Re: HTC 23709_22274 Cady Lofts Material Amendment Request and Change to Financing Structure

This letter concerns a material amendment request for HTC 23709_22274 Cady Lofts in Austin. Cady Lofts is a supportive housing application that received a Housing Tax Credit award in 2022, Force Majeure in 2023, a HOME ARP award in 2023, and State Tax Credits in 2024.

CADY LOFTS

ARCHITECTURAL SITE PLAN

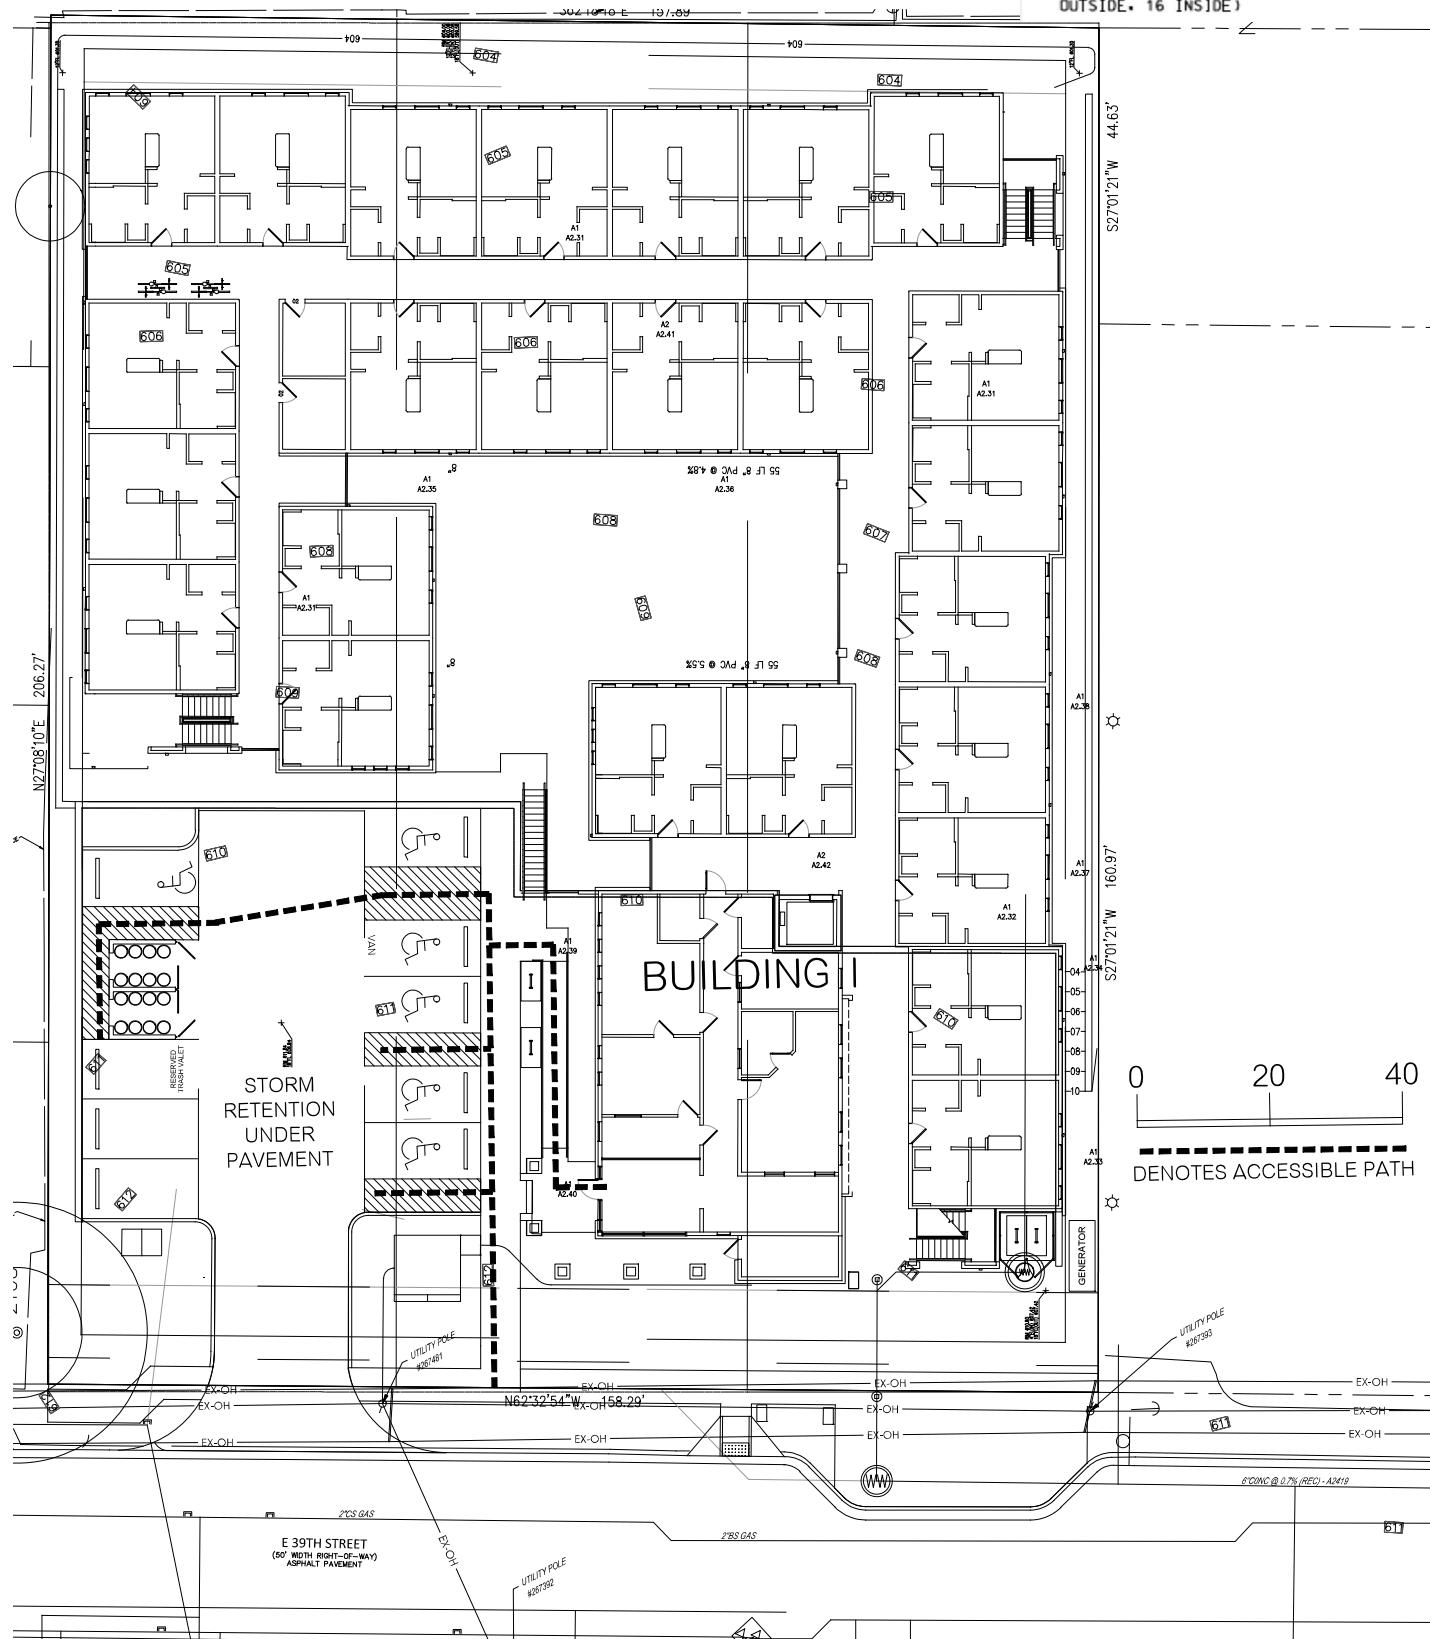
During the site plan approval process, the neighborhood was concerned that there was not adequate open space for the residents. Also, subsequent engineering and site work revealed that the natural topography of the development site actually had considerable slope front to back, which was altered and obscured by the existing single-family homes that were on the property. In consideration of these items, the site plan was changed from a 4-story building with ground-level podium parking to a split-level 4-story building that would follow the natural contour of the development site. The interior courtyard area was increased and common area space was distributed to three of the four floors to better serve the residents. Parking was moved from the ground floor of the building to a surface lot that contains underground detention. Total parking spaces were reduced from 29 to 9; however, the development still exceeds the City of Austin parking requirements.

The change from a 4-story building with podium parking to a 4-story split-level building with surface parking reduced site work and building costs. We also believe that the new site plan and architectural design of the development is an overall improvement for the supportive housing residents.

9 SPACES (3 STD., 6 ACCESSIBLE),
24 BIKE (4 SHORT-TERM OUTSIDE, 4 LONG-TERM
OUTSIDE, 16 INSIDE)
